REMARKS

Fig. 1

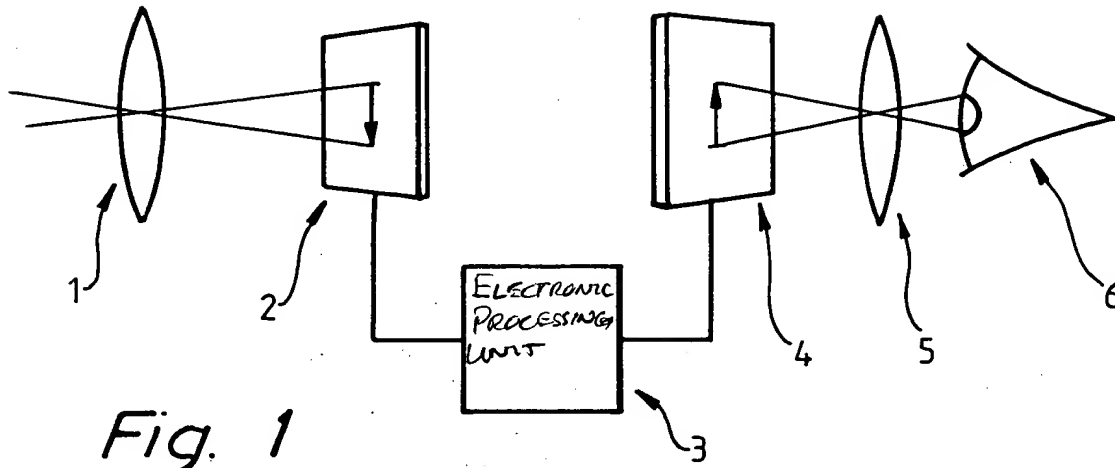
The Office Action also includes an objection to the drawings suggesting that the symbolically illustrated structure bare legends. Concurrently filed herewith is a Request for Approval of Drawing Changes in which element 3 of Figures 1 and 2 is to be labeled with the legend "Electronic Processing Unit". Approval of these drawing changes and withdrawal of this objection are respectfully requested.
